Mussetter Engineering Inc.

Memorandum

Project: 04-31

Subject: DRAFT Comments for Design Features. Main Branch Calabacillas Arroyo

Figure 1. Upstream face of McMahon Bridge crossing (perpendicular to the direction of flow.)

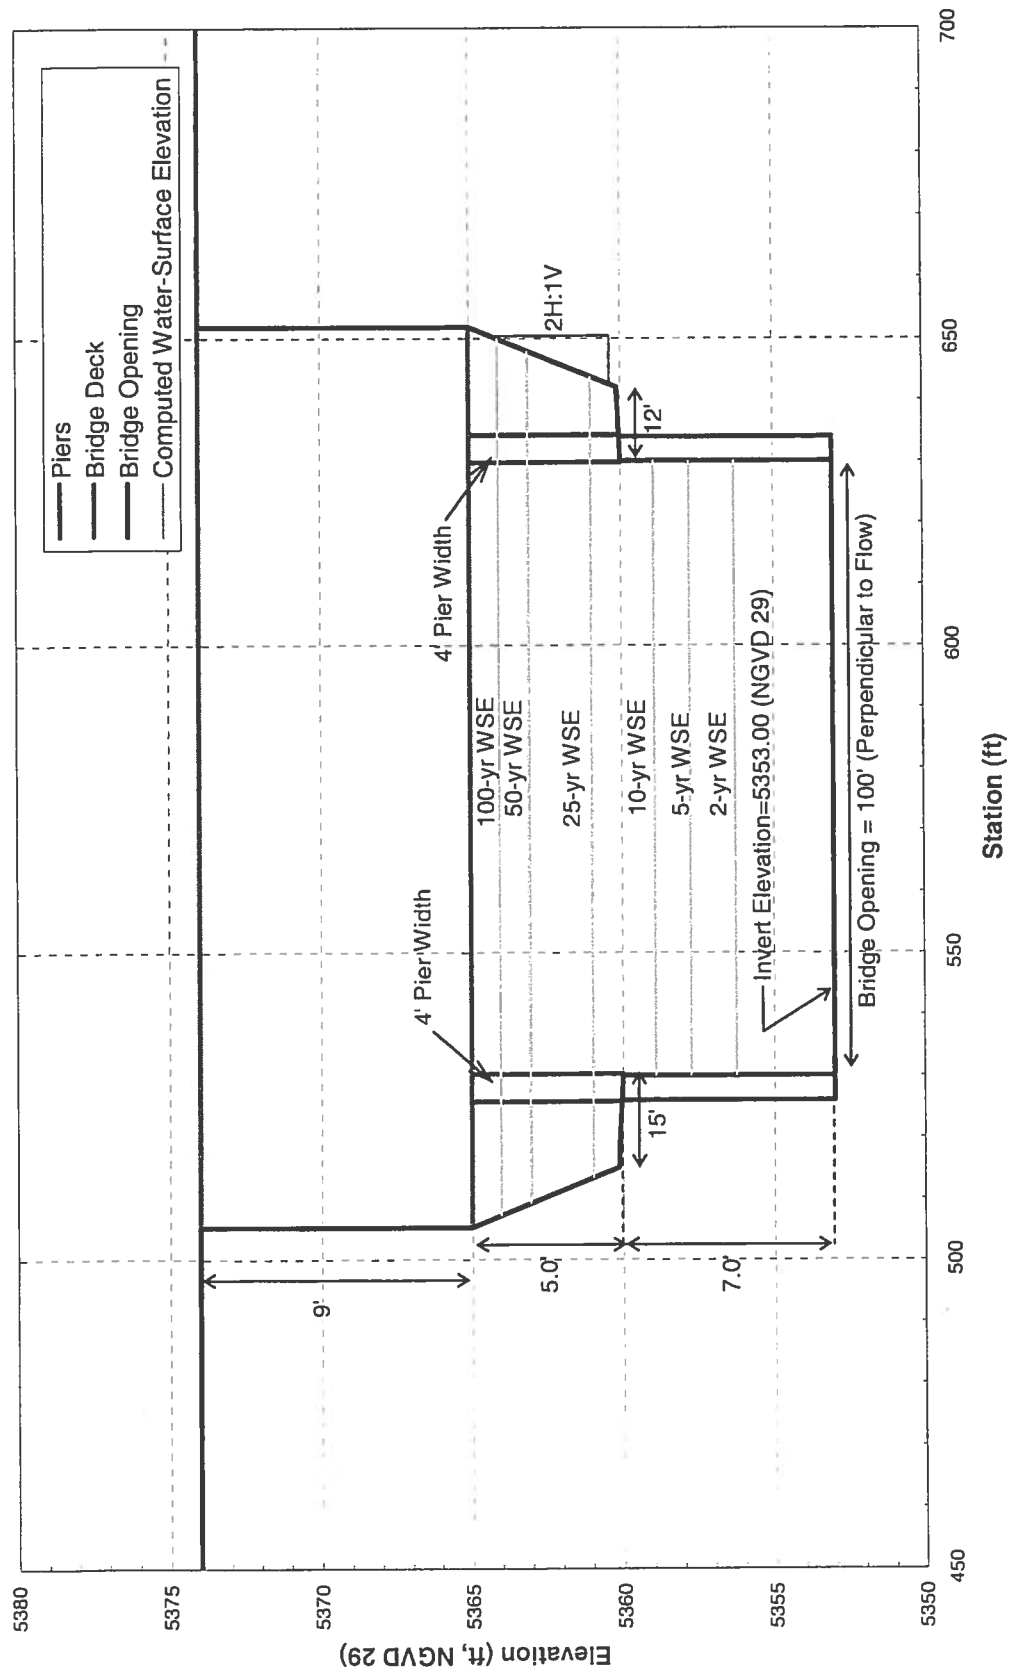
4. The current alignment of Spurs 5L, 5R, and 4L will direct the majority of flow into the upstream face of the right bridge abutment. Improved alignment of the flow into the bridge opening could be achieved by removing or significantly reducing the length of Spur 4L, adding Spur 4R adjacent to Spur 4L, and shifting Spurs 5L and 5R about 70 degrees toward the left bank. (The flow alignment could also be improved by shortening Spur 5L and lengthening Spur 5R).

Figure 2. Computed 100-year water-surface profiles through the project reach.

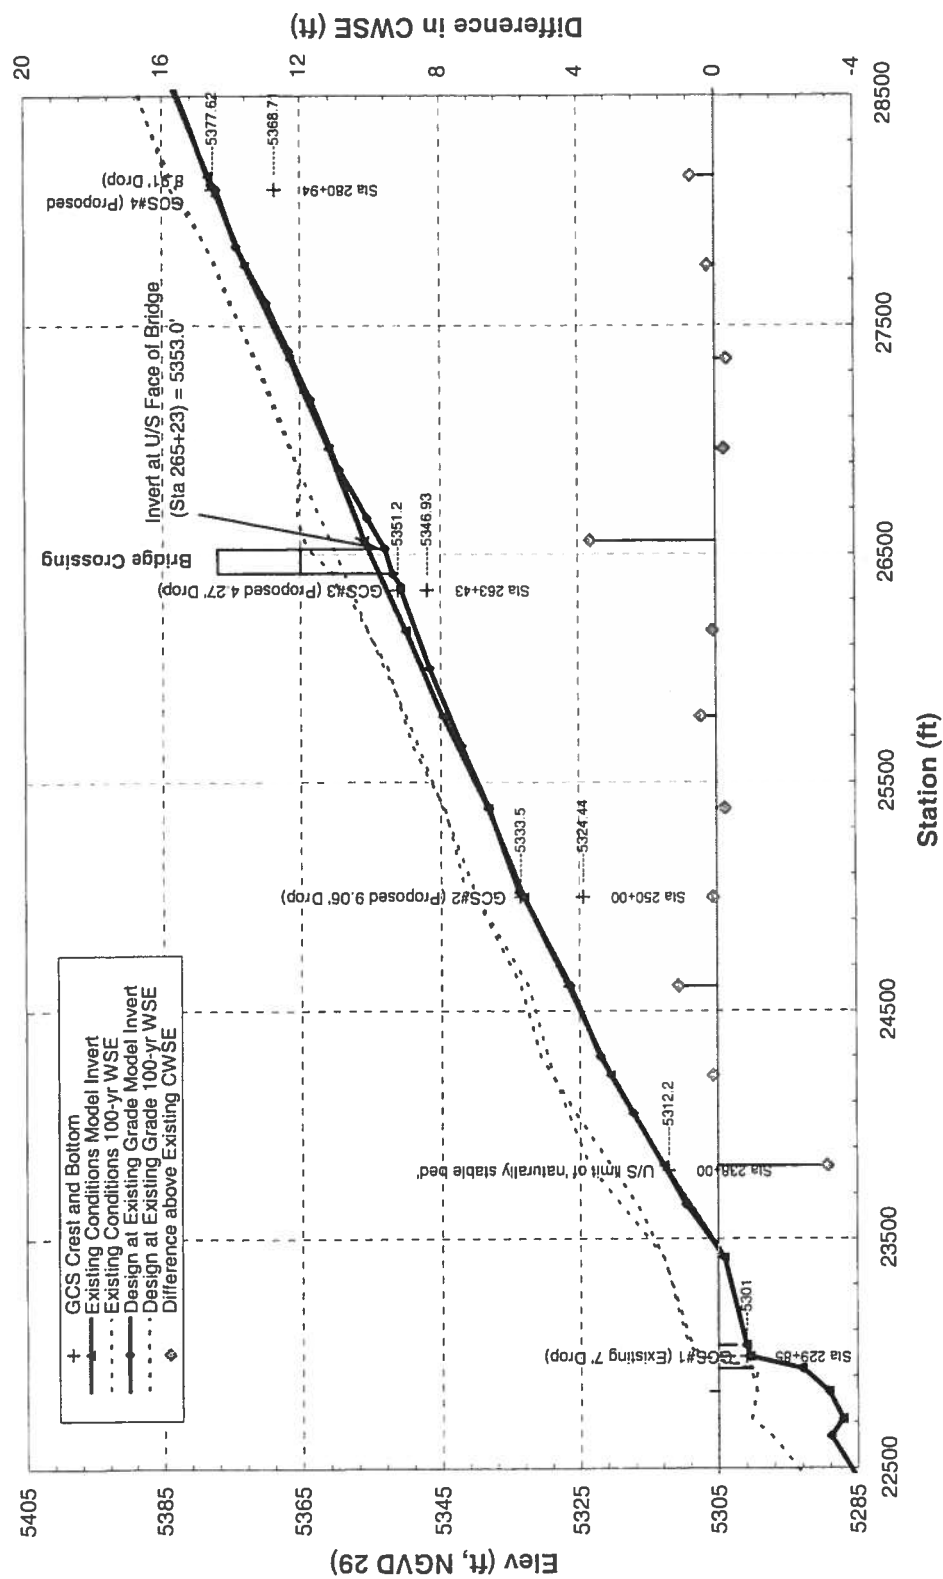
A one-dimensional (1-D) hydraulic analysis of the project reach was conducted using the U.S. Army Corps of Engineers HEC-RAS software package (USACE, 2004) to evaluate the changes in hydraulic characteristics associated with the design. The analysis indicates that the design will result in relatively minor changes in the hydraulic characteristics from existing conditions in most areas, but backwater conditions will occur upstream from the McMahon Bridge crossing for flows greater than the 10-year event. At the peak of the 100-year flood, the increase in water-surface elevation is nearly 4 feet (**Figure 2**.)
